Addendum No. 3

September 10, 2021

Project: San Fernando Regional Park Infiltration Project

**Attachment 4: Revisions to Diversion Pipe Plan and
Profile from Glenoaks Boulevard**

SECTION C

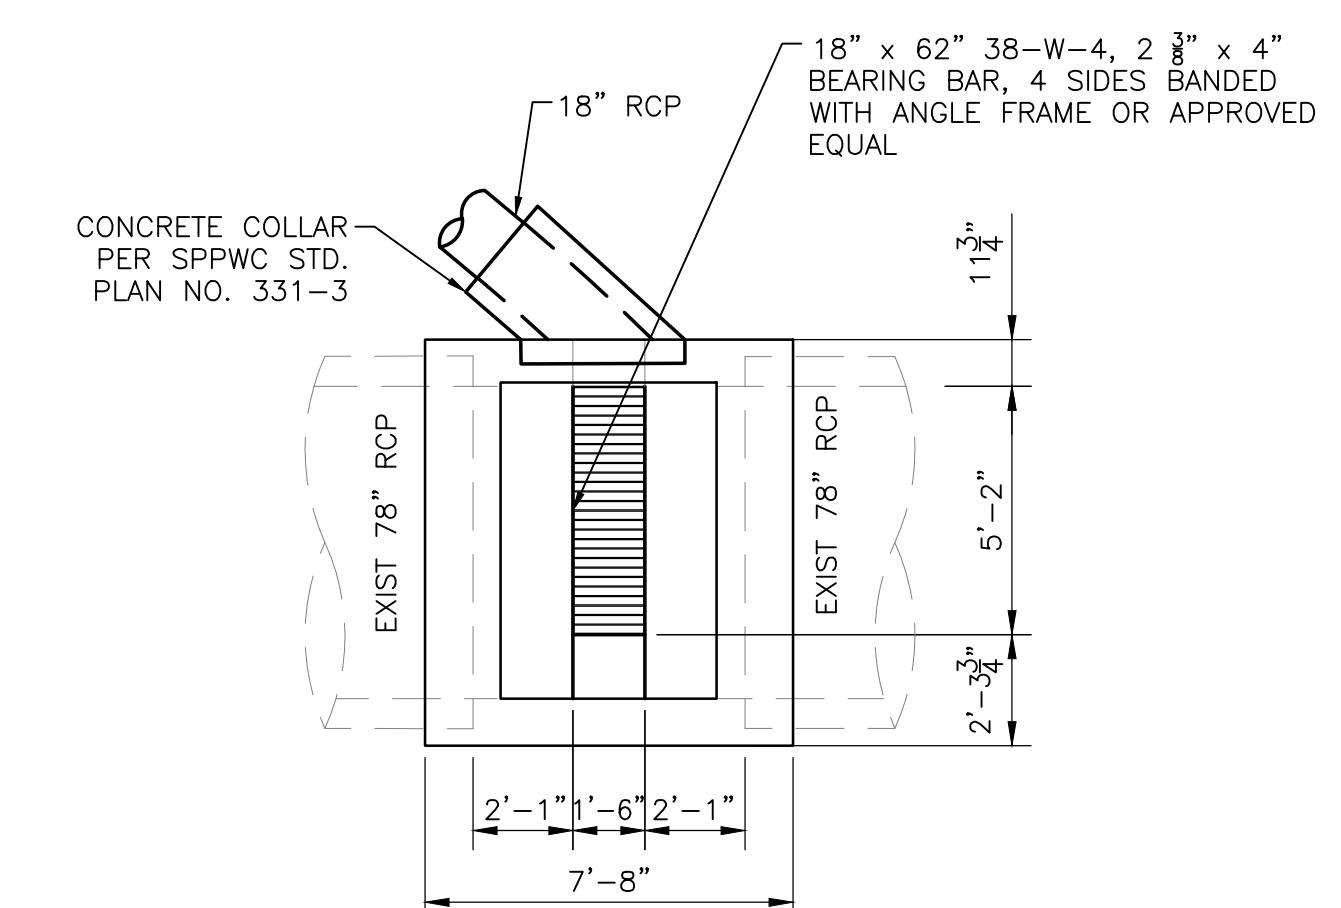
REV.	DATE	BY	DESCRIPTION	APP'D
1	9/7/21	TT	ADDED EX. SEWER LINE TO PROFILE; REVISED PIPE INVERT/SLOPE	
2	9/10/21	TT	ADDED HOUSE CONNECTION NOTE UNDER NOTES TO CONTRACTOR

LS-01

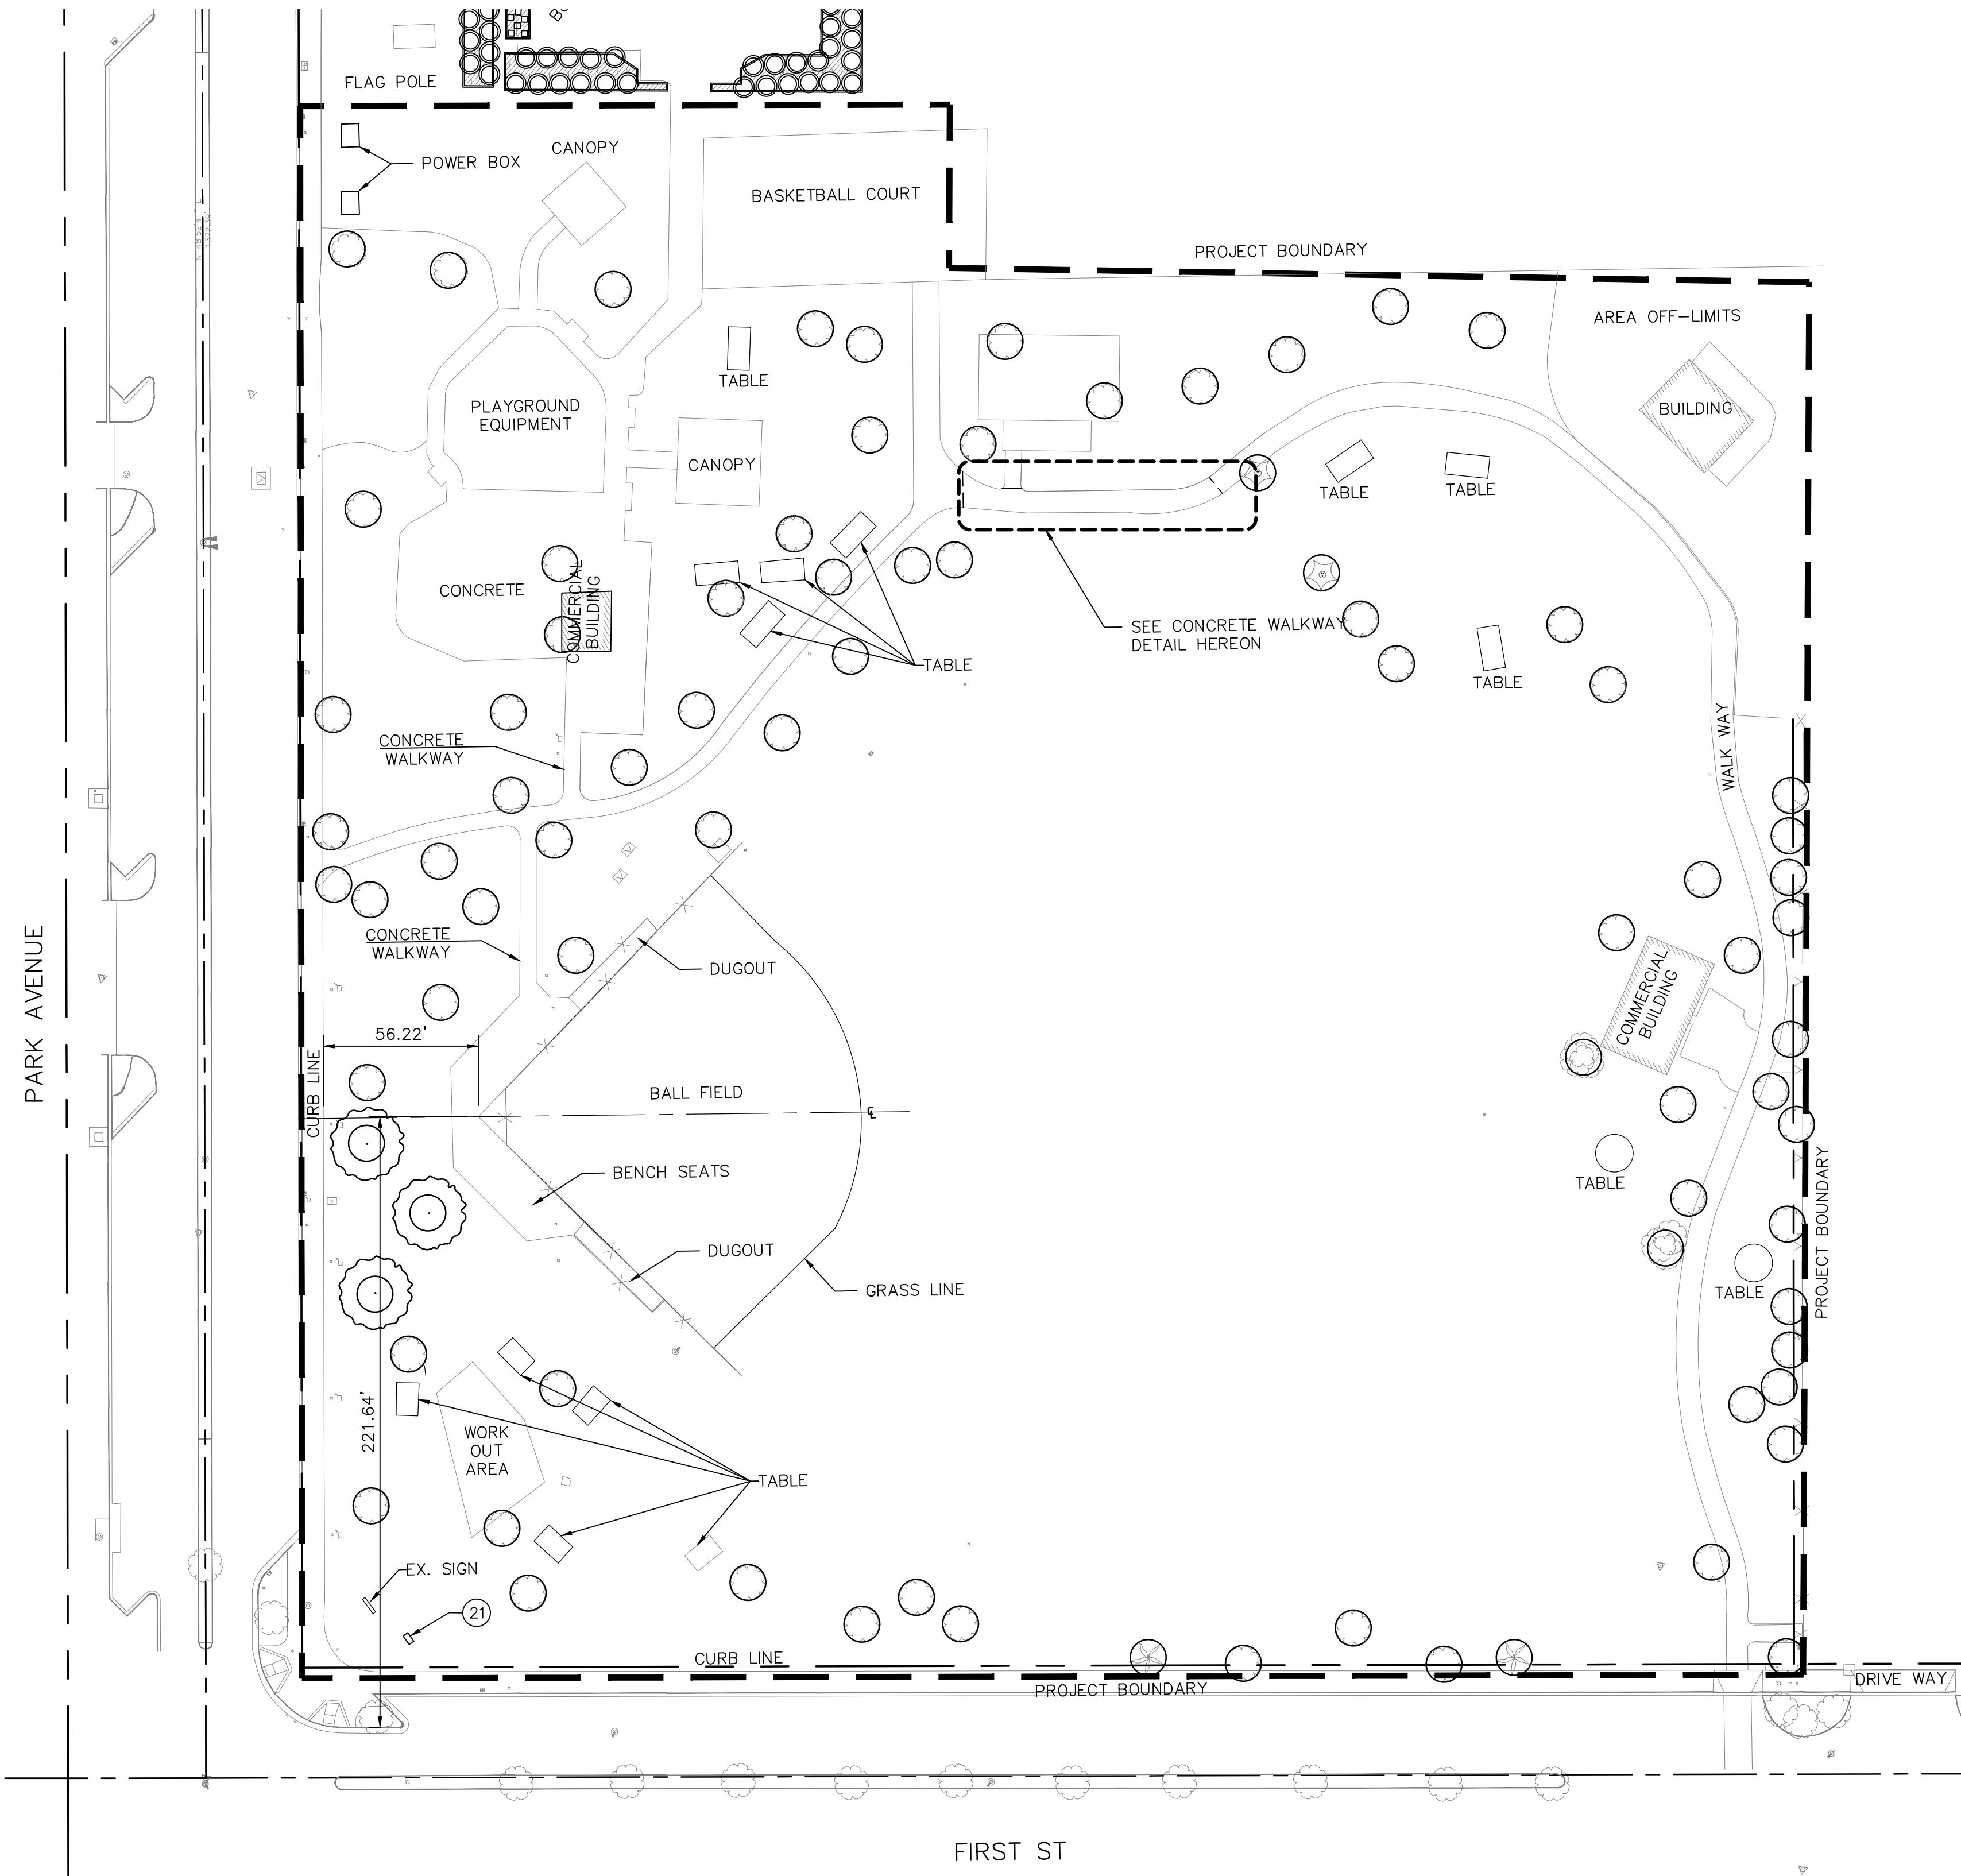
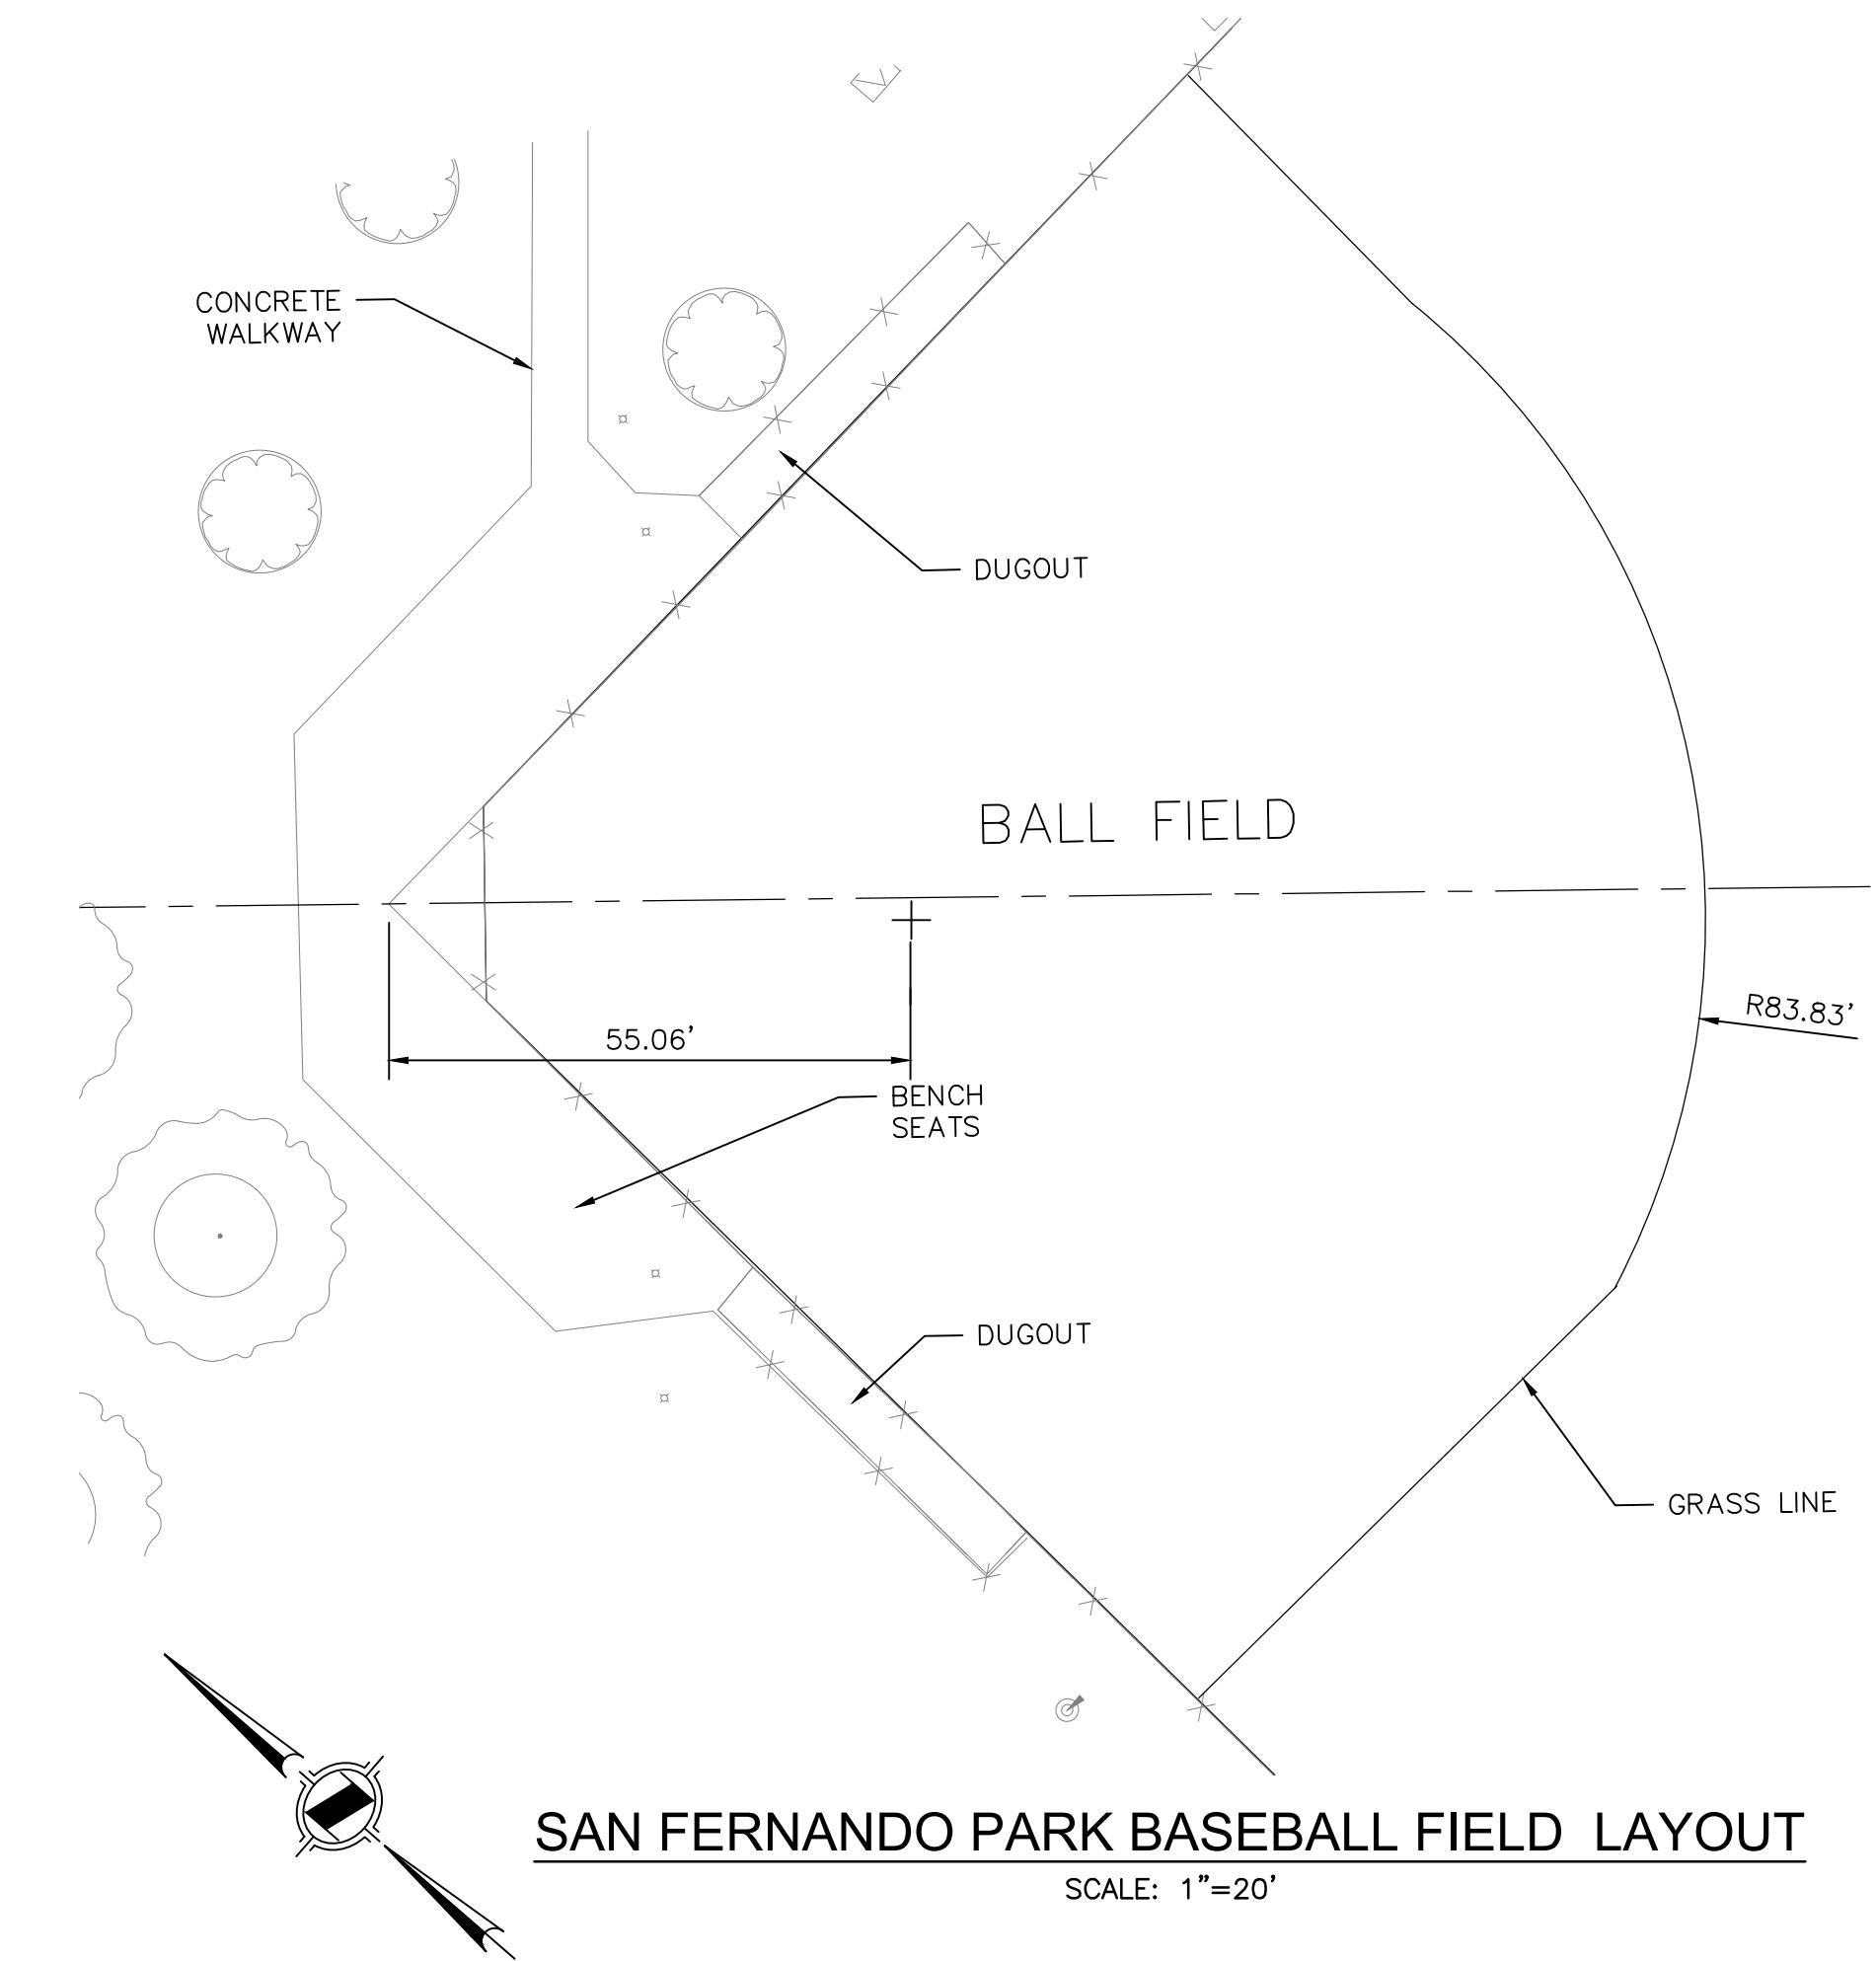
Question #51: The drawing LS-02 scale is incorrect. Please issue correct drawing scale.

REV.	DATE	BY	DESCRIPTION	APP'D
3	9/10/21	TT	REVISED SCALE

Answer #51: Revised landscape sheets are attached to this addendum as Attachment 5.
